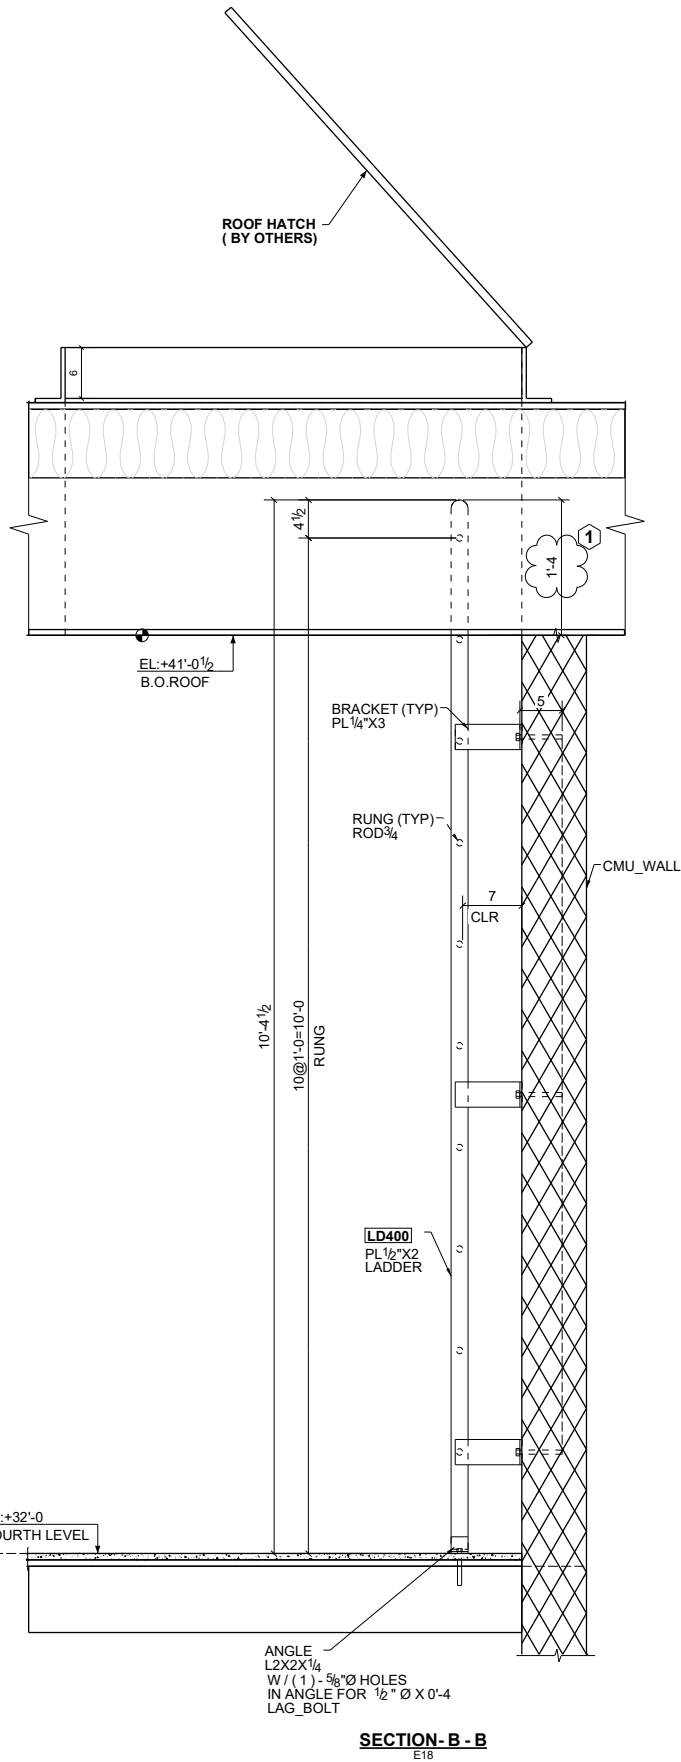
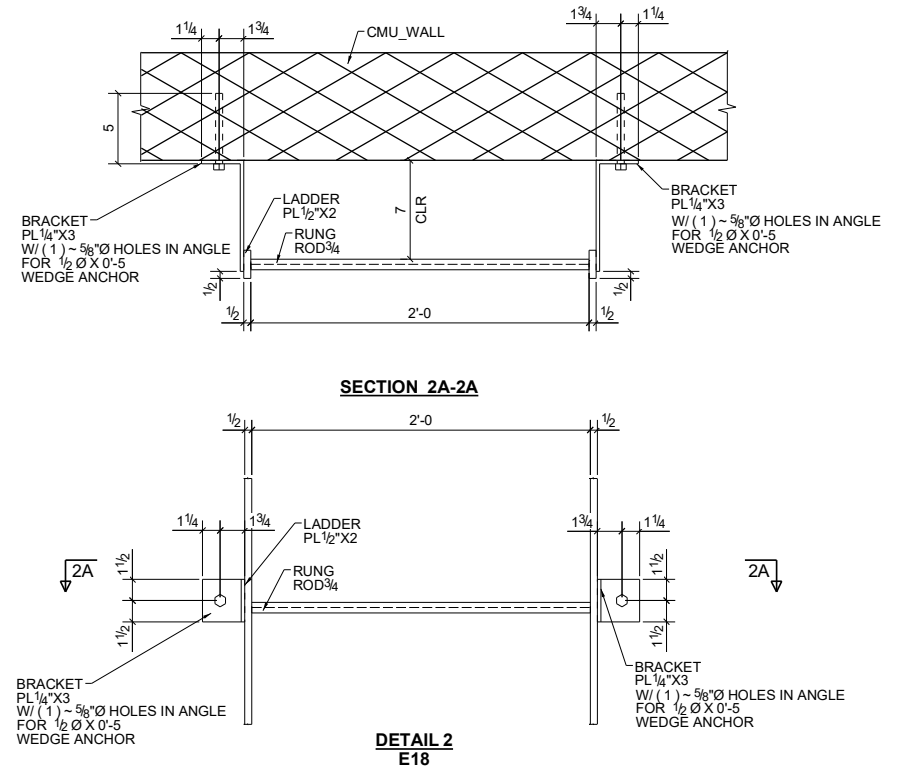
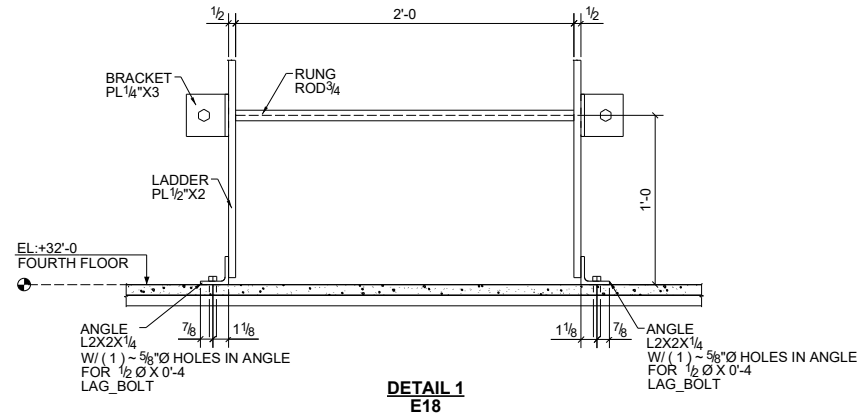
1 WE ARE EXTENDING THE LADDER HEIGHT 16" FROM BOTTOM OF ROOF AND ADDING 1 QUANTITY RUNG SO THAT IT CAN BE ADJUSTED WHEN REQUIRED IN FIELD PLEASE CONFIRM PRIOR TO FABRICATION AND ERECTION.
